Subject: ER # 2017-2210-042 Site Modifications

Adelphia Gateway, LLC (Adelphia) is proposing some modifications to nine Adelphia Gateway Project (Project) sites. Although the modifications are relatively minor and would not include any new excavations outside of existing trenches, the PA DEP is requesting PHMC review of the modifications as part of their Completeness Review for the associated Phase 1 Major Amendment to the Project's Erosion and Sediment Control Permit application.

The sites along with a description of the proposed modifications are listed below. I've also included figures depicting the changes between the site layouts reviewed by the PHMC and those that are currently proposed under the Phase I Major Amendment.

# Marcus Hook Compressor Station

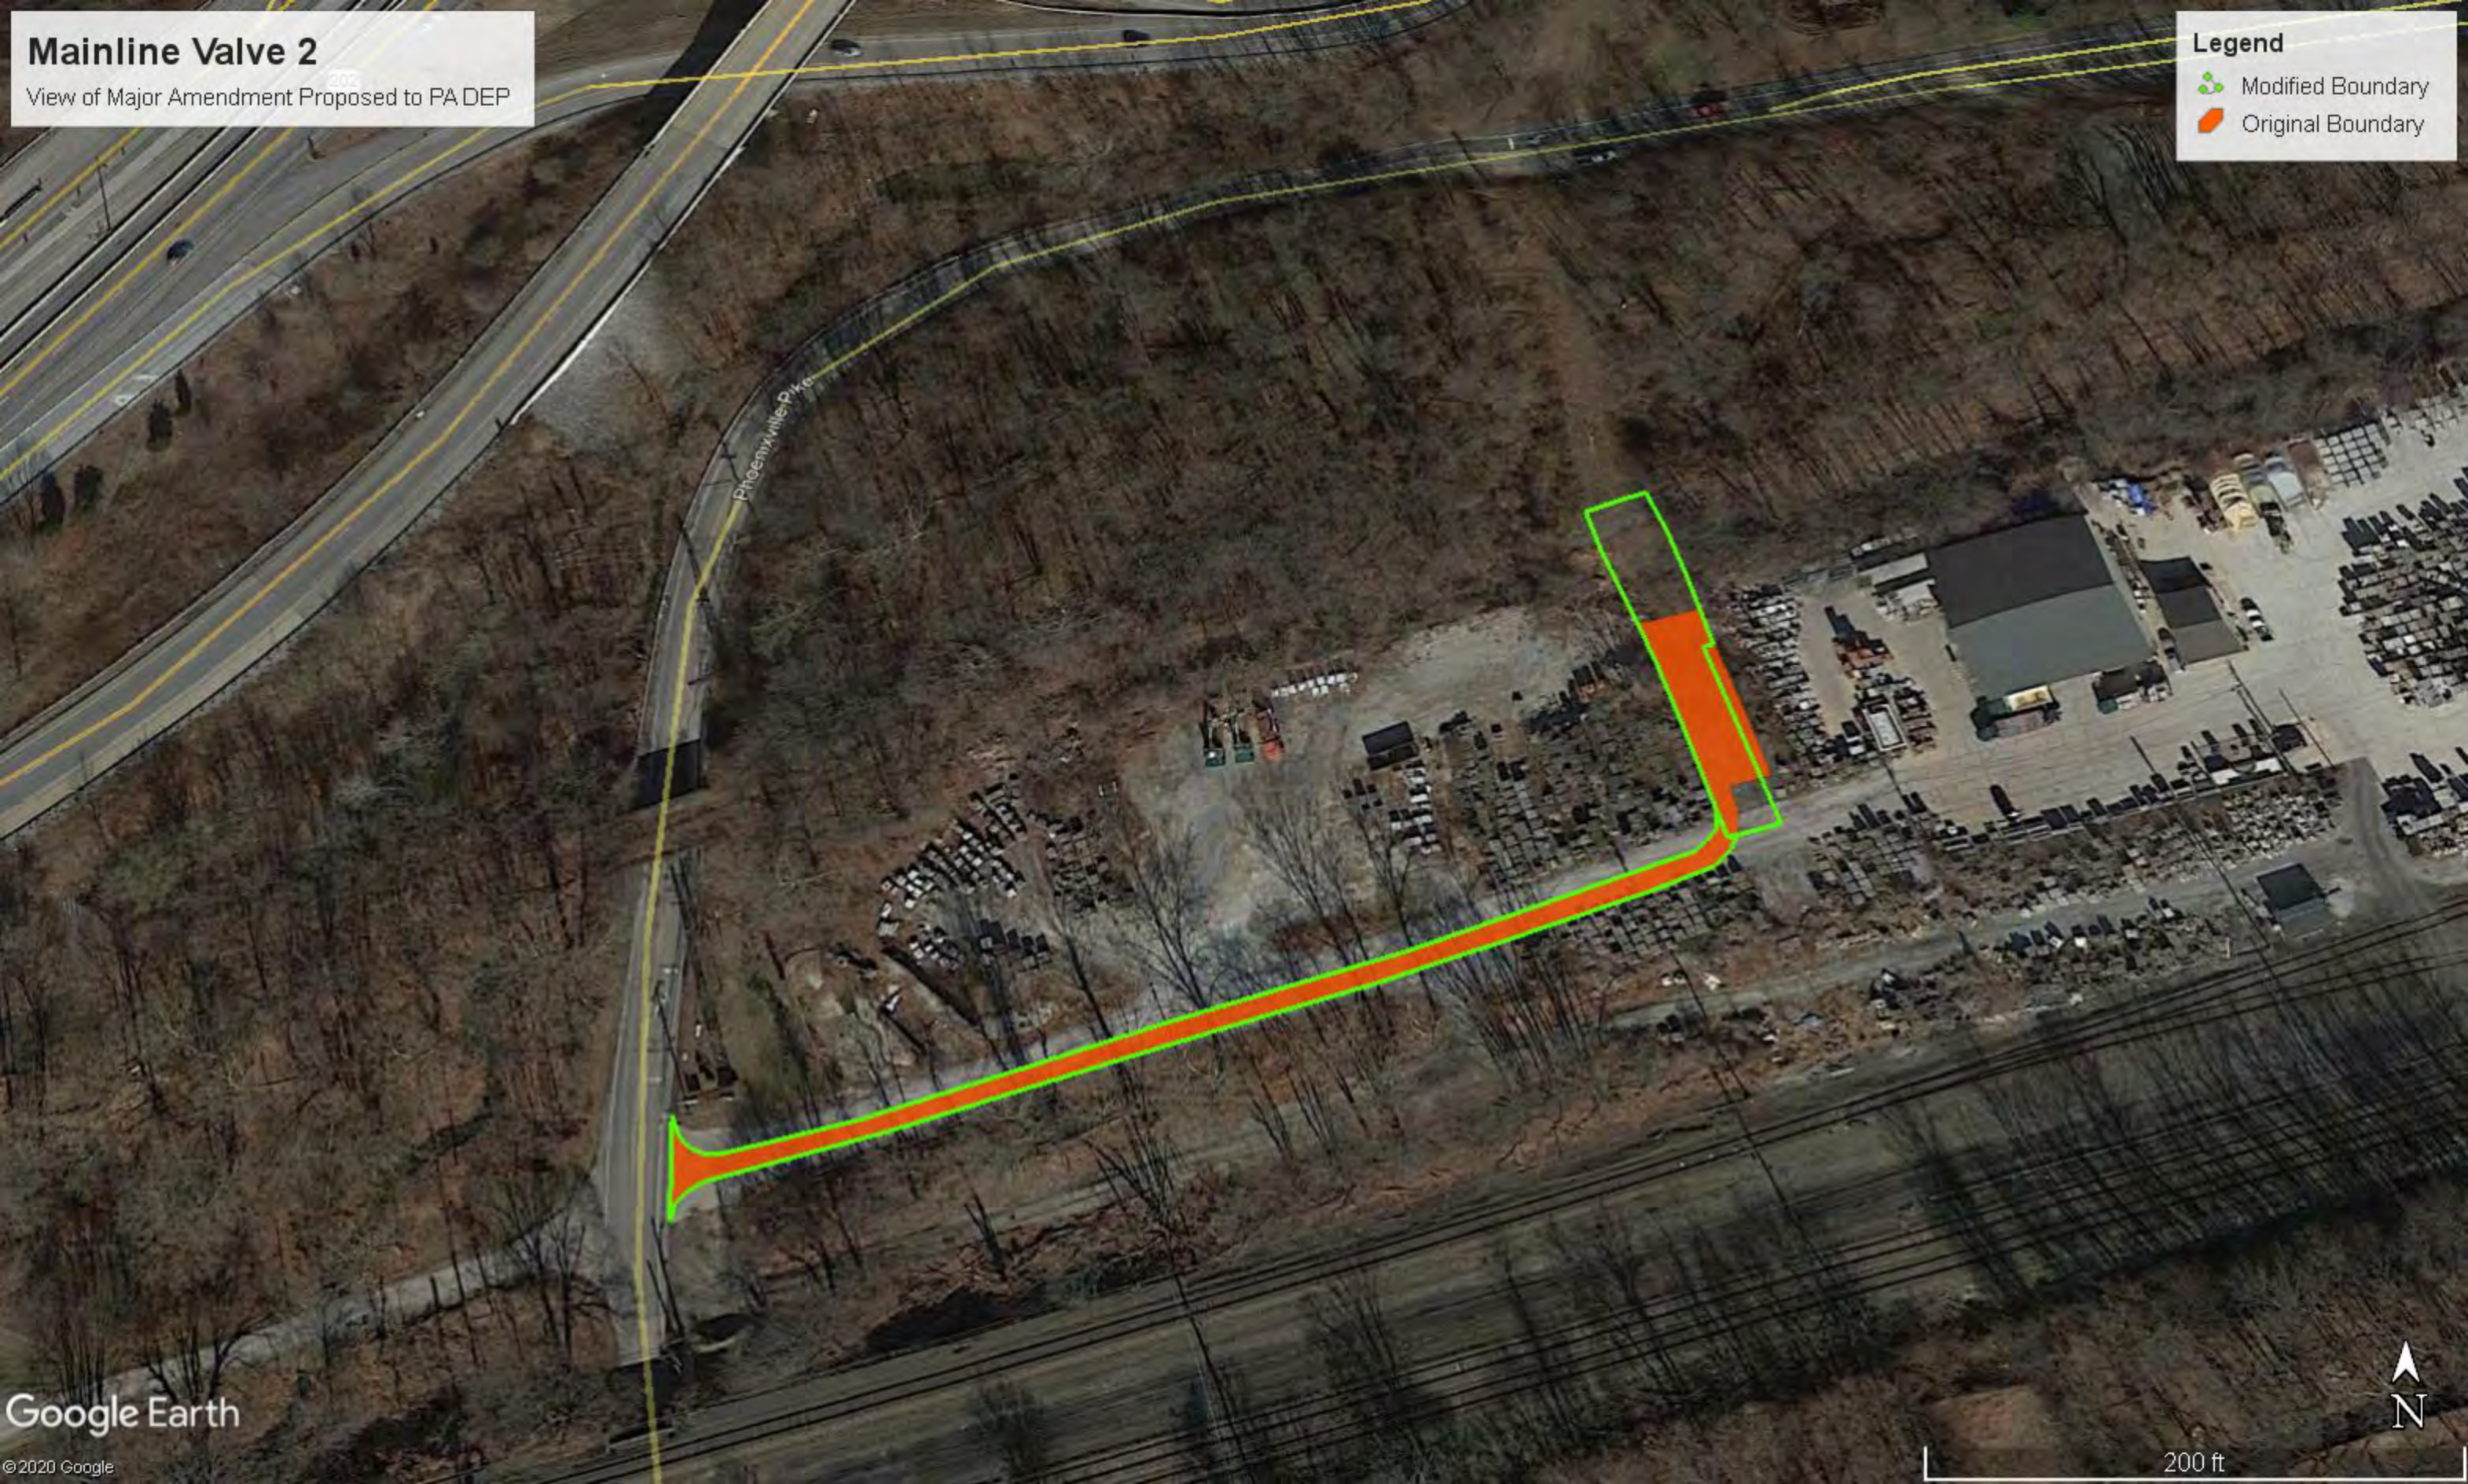
4. **Marcus Hook Compressor Station** – Adelphia proposes to reduce the limits of disturbance for this site.
5. **Mainline Valve #2** – Adelphia proposes to add TWS north and south of the existing TWS within the existing maintained pipeline ROW to provide adequate workspace.
